November 6, 2018

Patrick Consulting Inc.  
PO Box 581, Stn Ganges  
Salt Spring Island, BC  
V8K 2W2  
(phone: 250-538-0215)

**RE: Peer Review of Additional Information, Proposed Upland Landfill, Campbell River, BC**

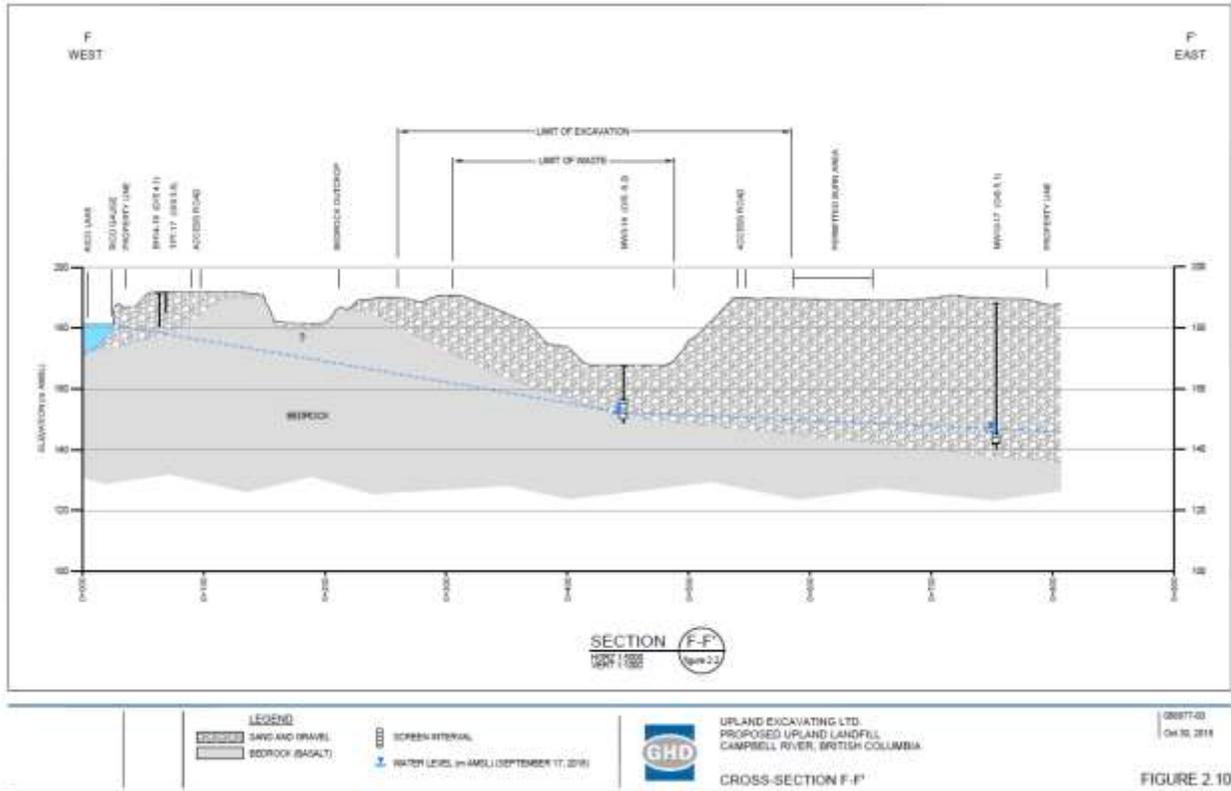
The presence of a perched zone or deeper water table at MW5A-15 has no influence on groundwater flow beneath the Site (refer to Figure 5.1 of GHD, reproduced above as Figure 1), or the potential to reverse the measured vertically upward hydraulic gradients from bedrock into the Sand and Gravel Aquifer.

Fractured bedrock is likely conveying a significant groundwater flux from Rico Lake to the east towards and beneath the Site. The groundwater contours presented on Figure 5.1 of GHD (reproduced as Figure 1 above), can be used to measure hydraulic gradients, which appear to have ranged from about 0.04 to 0.06 m/m in September 17, 2018. The gradients are significantly greater than the hydraulic gradient used by GHD in their analysis to estimate groundwater flux beneath the Site (0.03 m/m). The higher gradient in September 2018 indicates a greater groundwater flux on that date than estimated previously. Of relevance to the proposed landfill, greater measured gradients are indicative of larger groundwater fluxes beneath the proposed landfill which, in turn, indicate greater dilution of any mass loading from a liner leakage or failure scenario of the proposed landfill.

**Figure 2. East-west stratigraphic cross section prepared by GHD (from Figure 2.10, additional information, HHCR Report).**

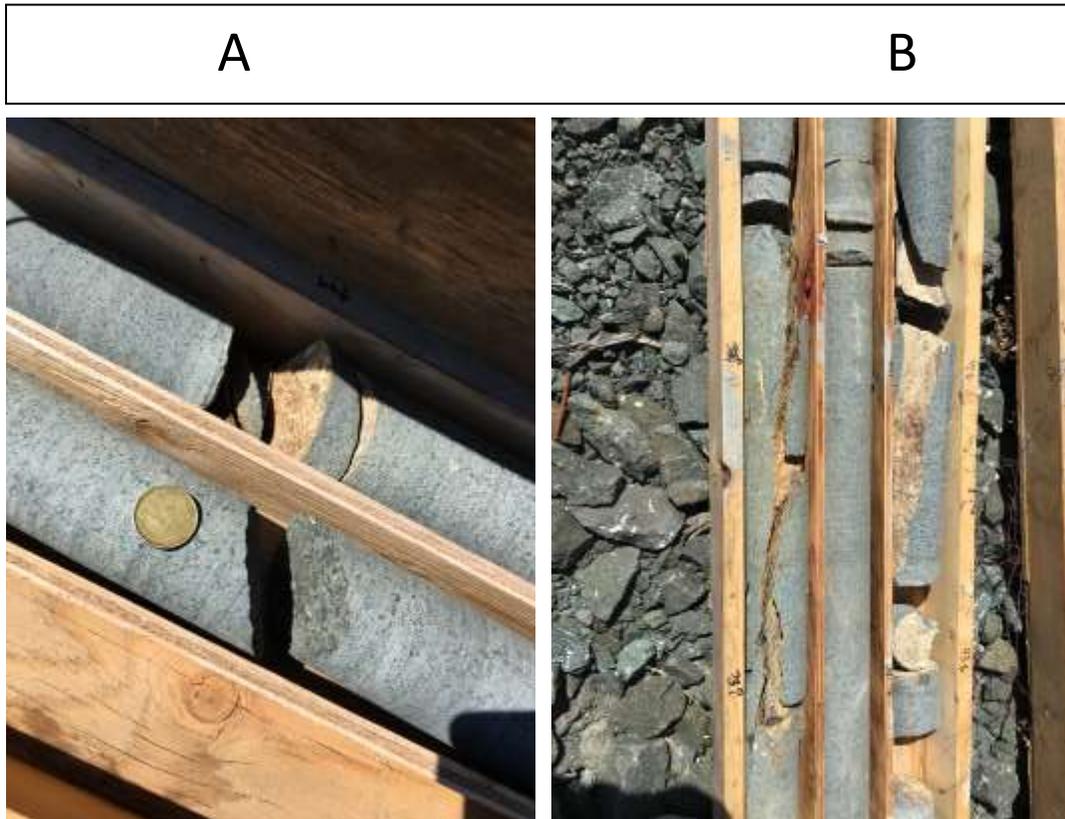
In their interpretation of Site geology, GHD states that the bedrock between Rico Lake and the Site “significantly restricts the movement of groundwater between these two features”, and makes reference to areas of competent versus fractured bedrock. Estimates of bedrock K were noted to be variable (i.e., MW15A-18,  $8.3 \times 10^{-3}$  cm/sec; MW14A-15,  $2.2 \times 10^{-2}$  cm/sec; and MW5A-15,  $1.4 \times 10^{-5}$  cm/sec).

In my view, GHD’s assessment understates the relevance of the fractured bedrock in conveying groundwater from Rico Lake to the Sand and Gravel Aquifer beneath the Site. Groundwater flow through the basalt occurs via secondary porosity features (i.e., open fractures), and the basalt bedrock across the Site is typically fractured (refer to Figure 3, below), as reported on all GHD borehole logs drilled into bedrock, and as I observed in rock cores from MW15A-18 and in bedrock outcrops during my Site visit.
